FINAL Carbon Basin Coal Project Environmental Impact Statement

FINAL
CARBON BASIN COAL PROJECT
ENVIRONMENTAL IMPACT STATEMENT,
CARBON COUNTY, WYOMING

**FINAL ENVIRONMENTAL IMPACT STATEMENT FOR THE
CARBON BASIN COAL PROJECT
CARBON COUNTY, WYOMING**

Figure 2.9 Generalized Mining Plan, Elk Mountain and Saddleback Hills Mines.

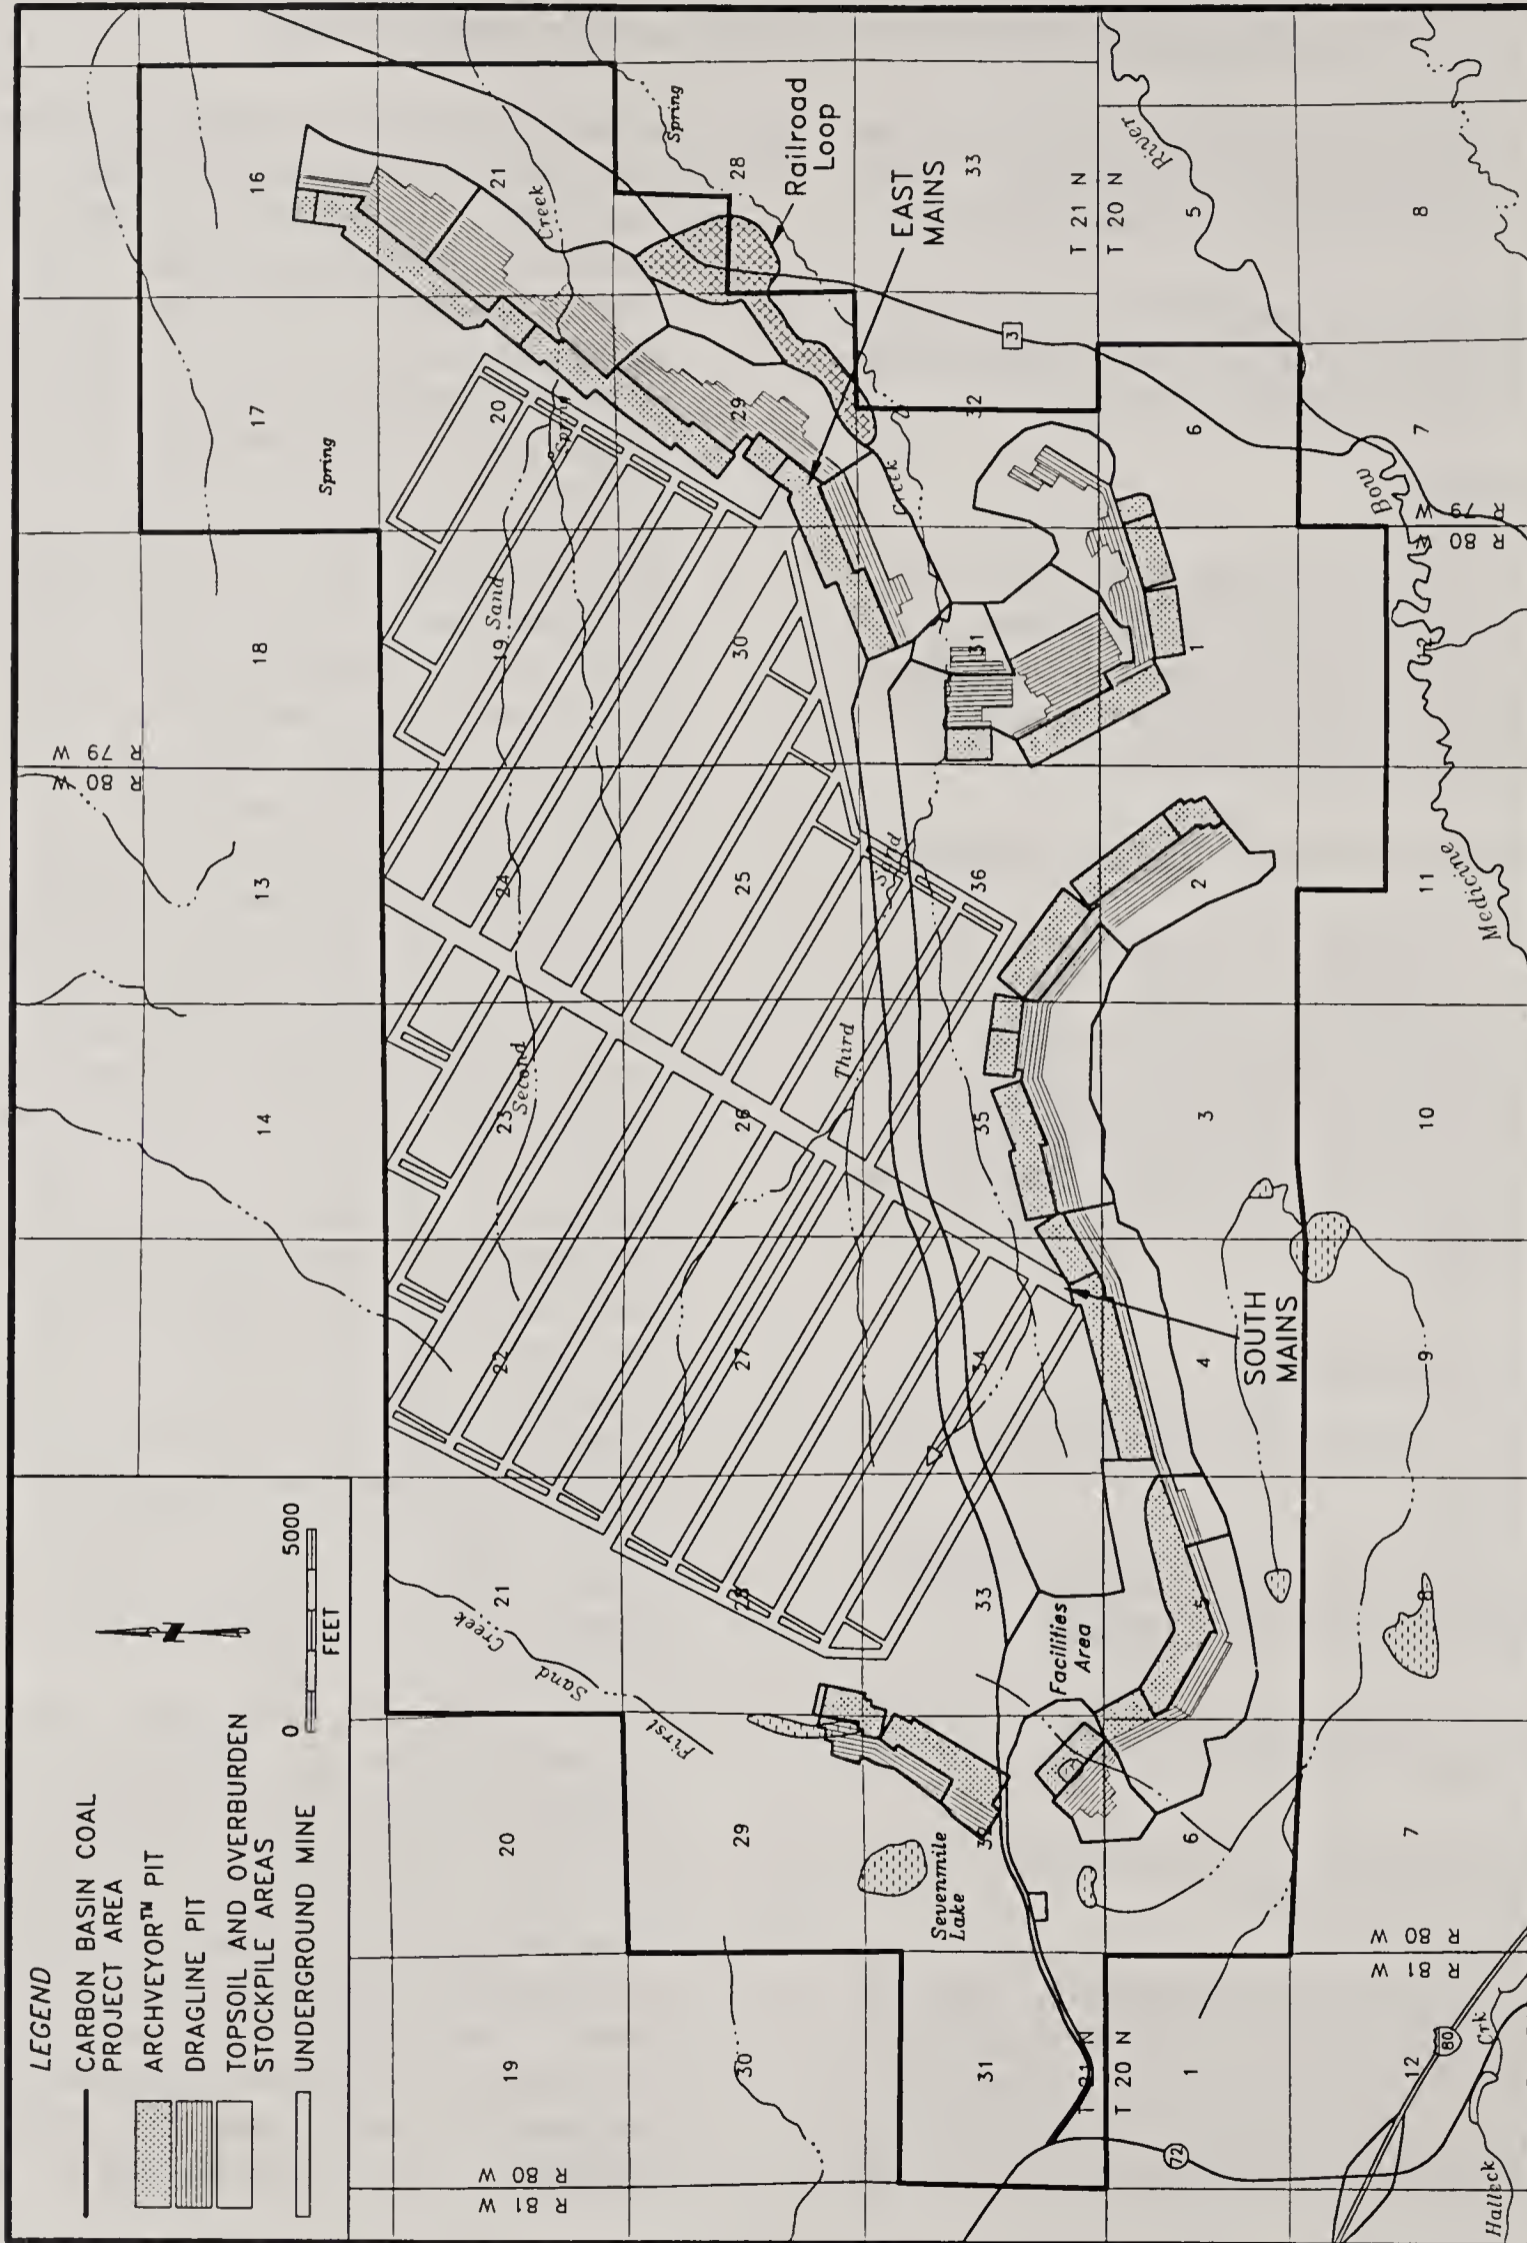
Page 2-36. Replace Figure 2.9 with Figure 2.9 on the next page.

- 1 We did, however, notice two minor errors in the document. The Carbon Basin Coal Project area is not plotted correctly on Figure 2.9 (page 2-36). It should include the entire longwall mine area to the north. And on Figure 3.2 (page 3-5), "Surficial" is misspelled at the top of the stratigraphic column.

Response to Comment I1 - Figures 2.9 and 3.2 have been corrected as requested.

Figure 3.2 Stratigraphy of the Hanna Formation (Morrison-Knudsen Company, Inc. 1983).

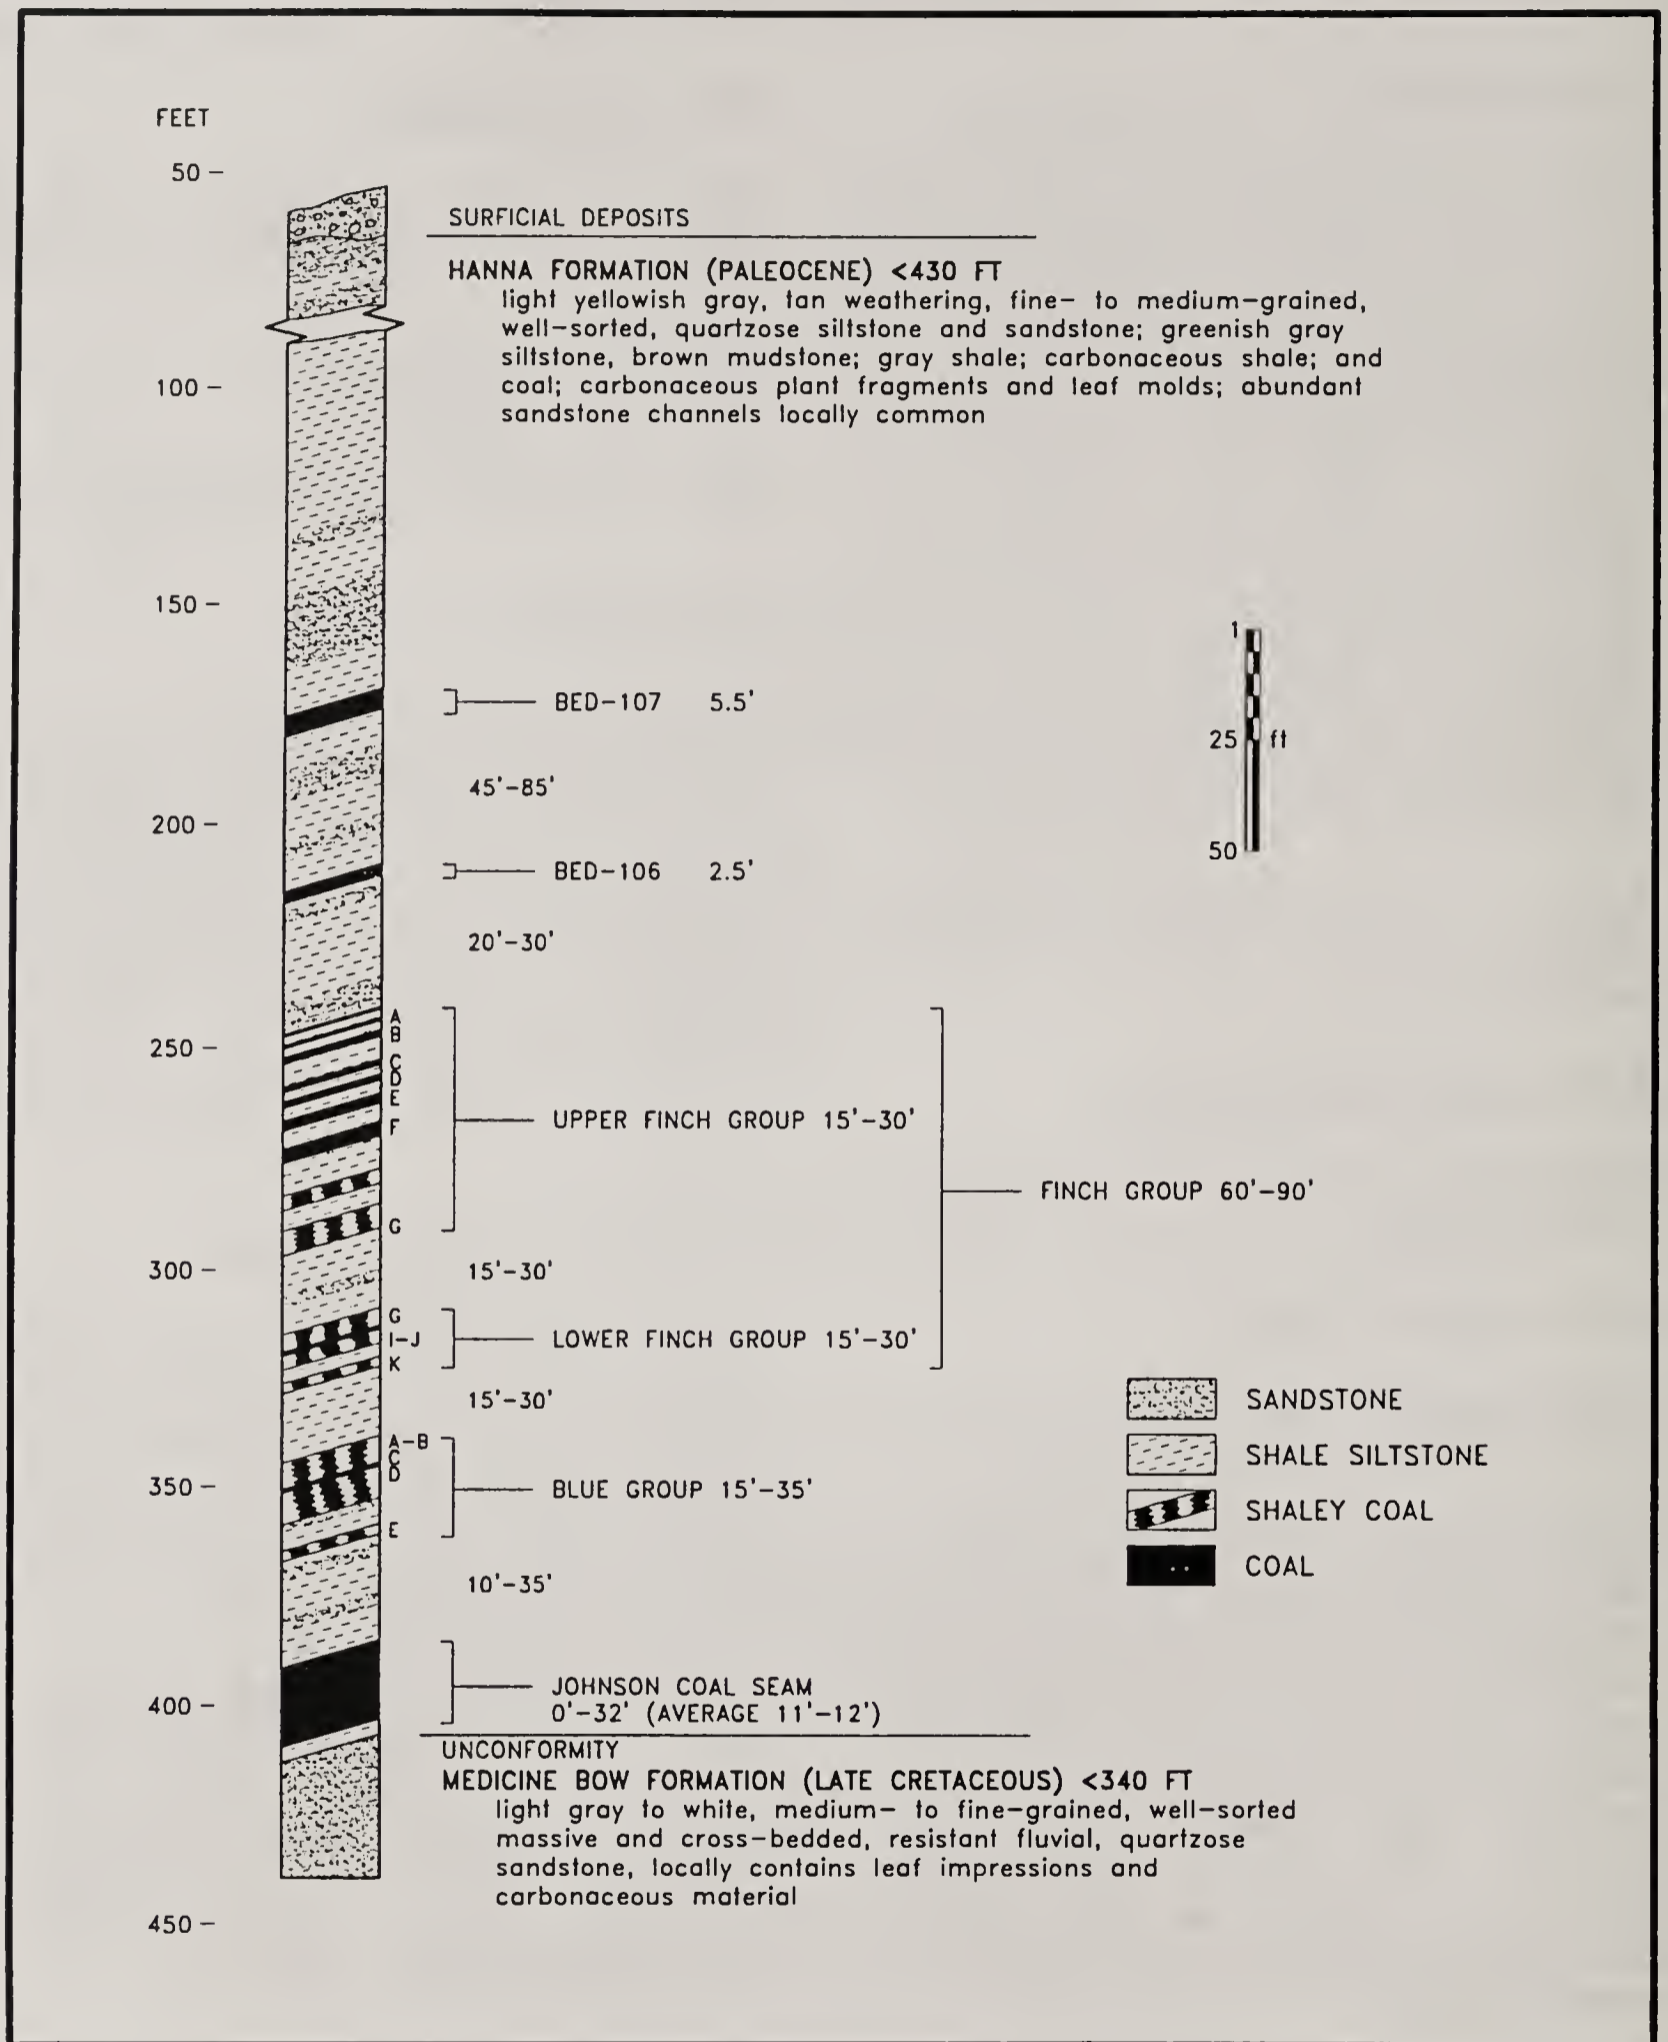
Page 3-5. Replace "Figure 3.2" with "Figure 3.2" on the next page.

Figure 4.5 Air Quality CIAA - 24-hour PM₁₀ Emissions.

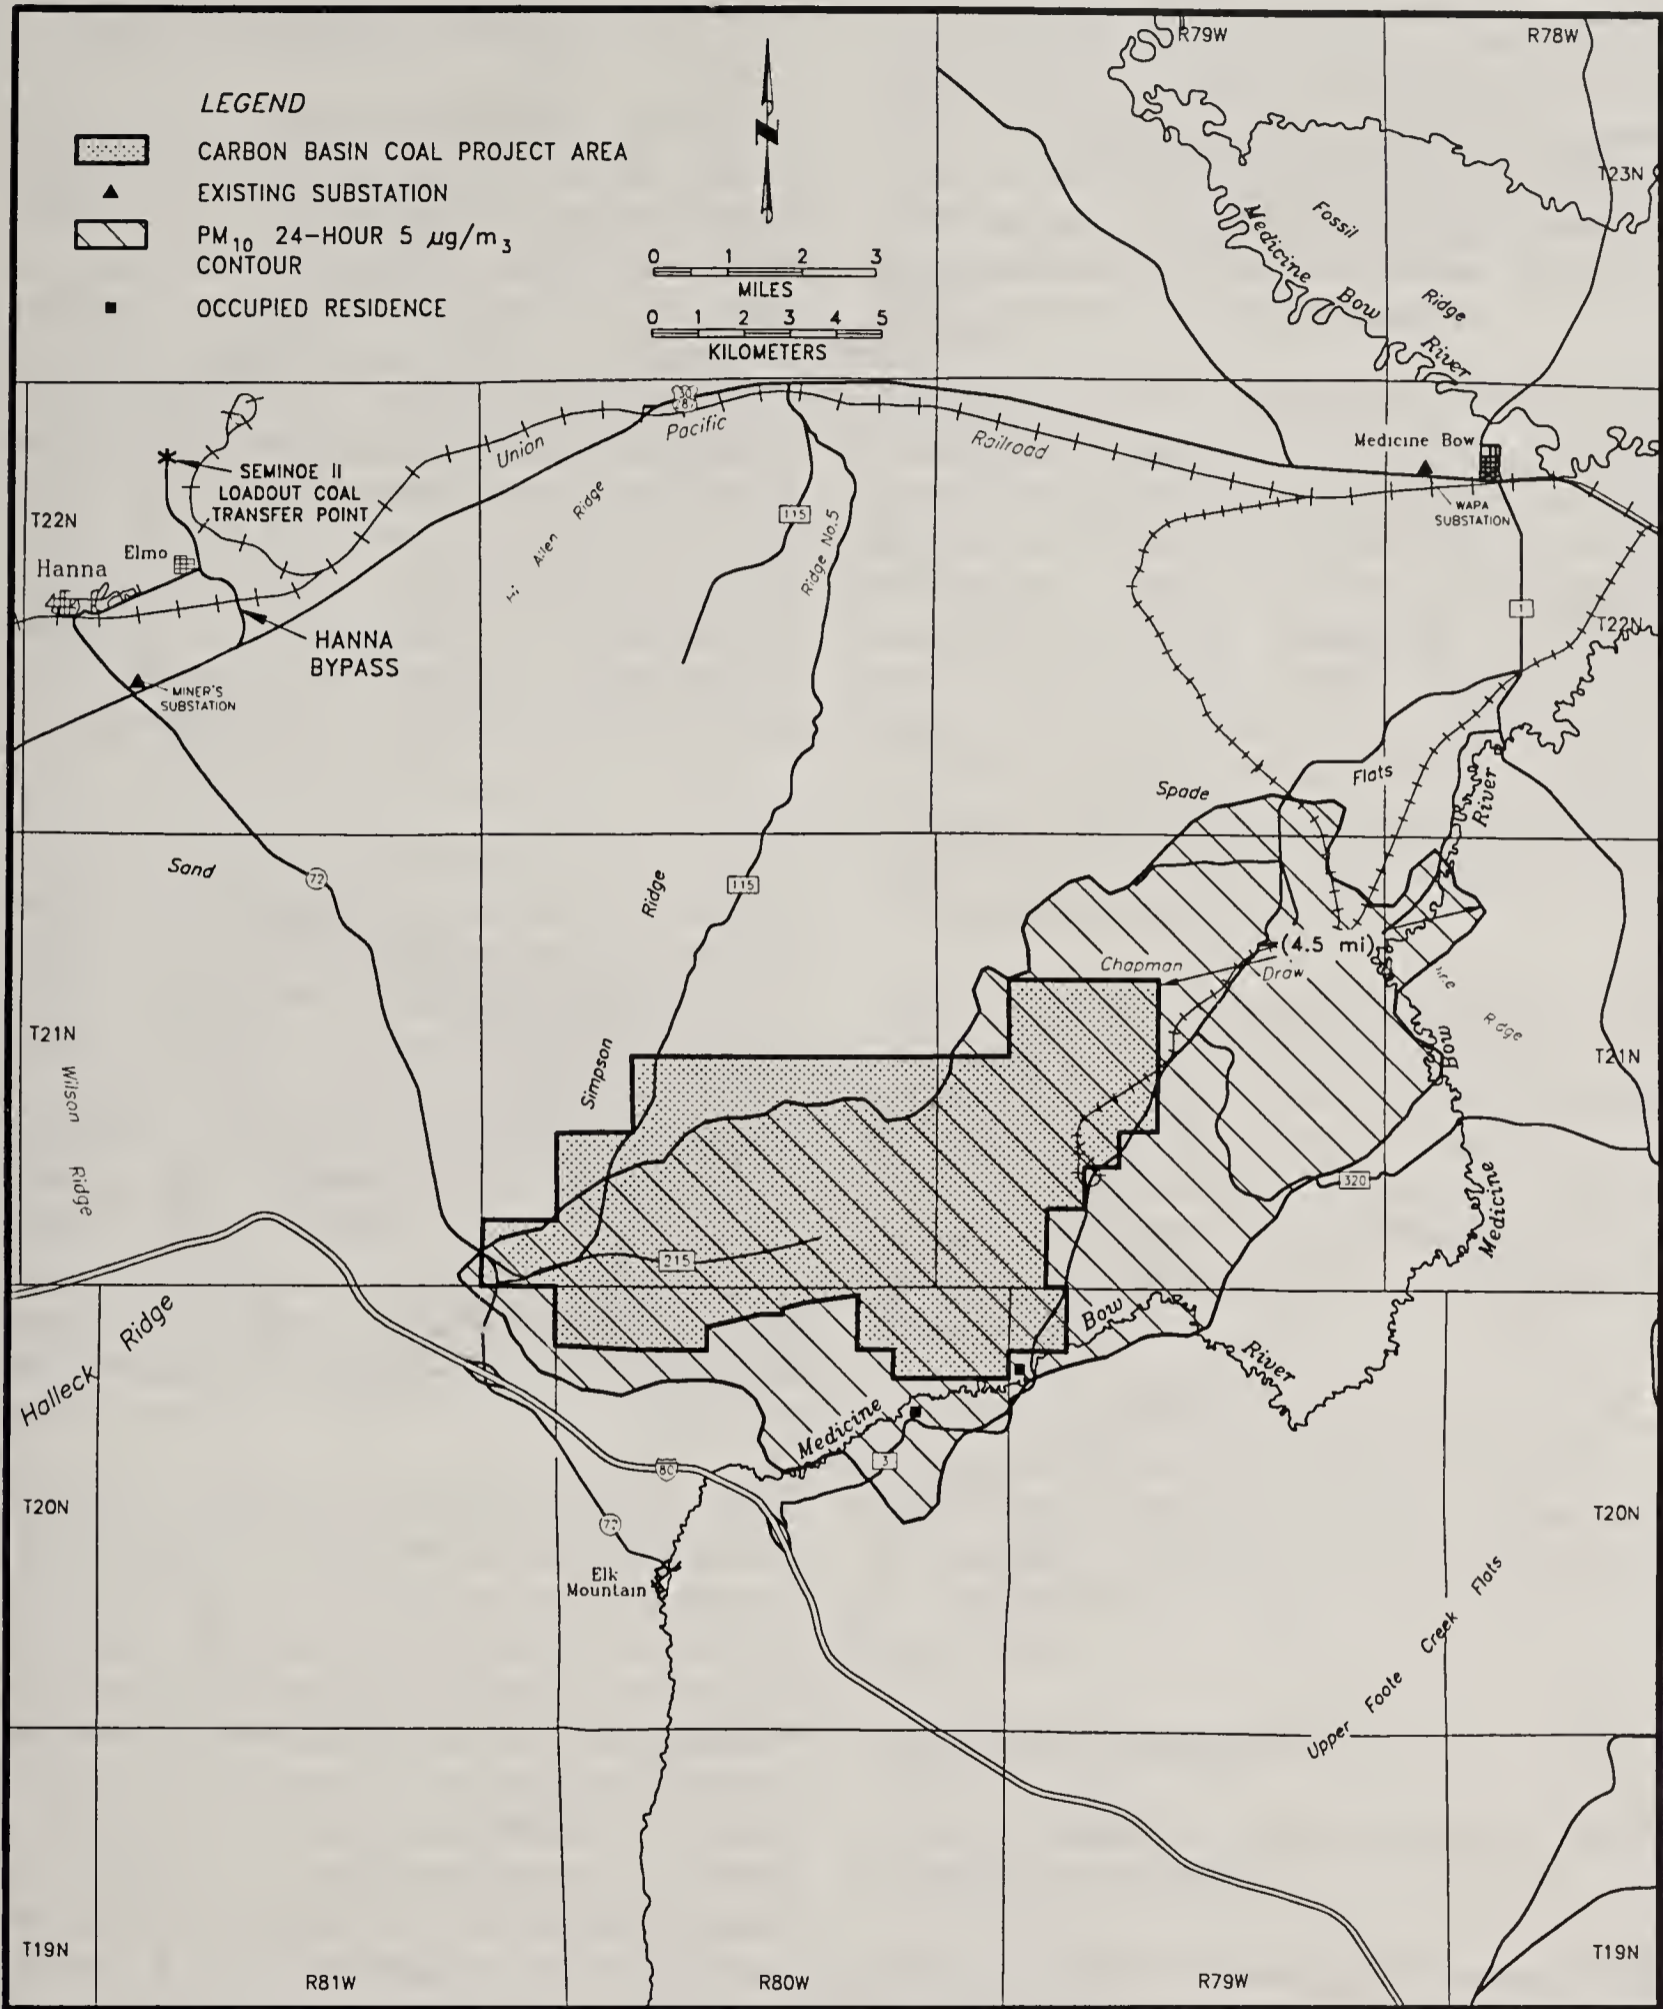
Pages 4-15 and 4-16, Figures 4.5 and 4.6. Replace with Figures 4.5 and 4.6 on the next page. "Figure 4.5 Air Quality CIAA - 24-hour PM₁₀ Emissions." "Figure 4.6 Air Quality CIAA - Annual PM₁₀."

- B.) Air quality: Ark Land assured me there would be minimal impact on the air quality, but the EIS indicates there would be significant impact. Review of figure 4.5, page 4-15 shows portions of my operation are located within the area most impacted with my homestead, improvements, hay meadows, summer grazing area, winter shelter area and calving grounds also being affected in various degrees.

Response to Comment K2 - Please refer to the new text in Section 4.1.2.4 which explains the cumulative effects figures (Figures 4.5 and 4.6) and corrects the statement that cumulative air quality impacts would be significant. Cumulative air quality effects would not be significant.

As stated on page 4-14, maximum particulate matter concentrations would comply with EPA primary and secondary ambient air quality standards at all areas near the mine to which the public can be exposed. Demonstrated compliance with these ambient air quality standards is required before WDEQ and EPA would allow mine construction. Residents near the mine would not be adversely affected by air quality impacts.
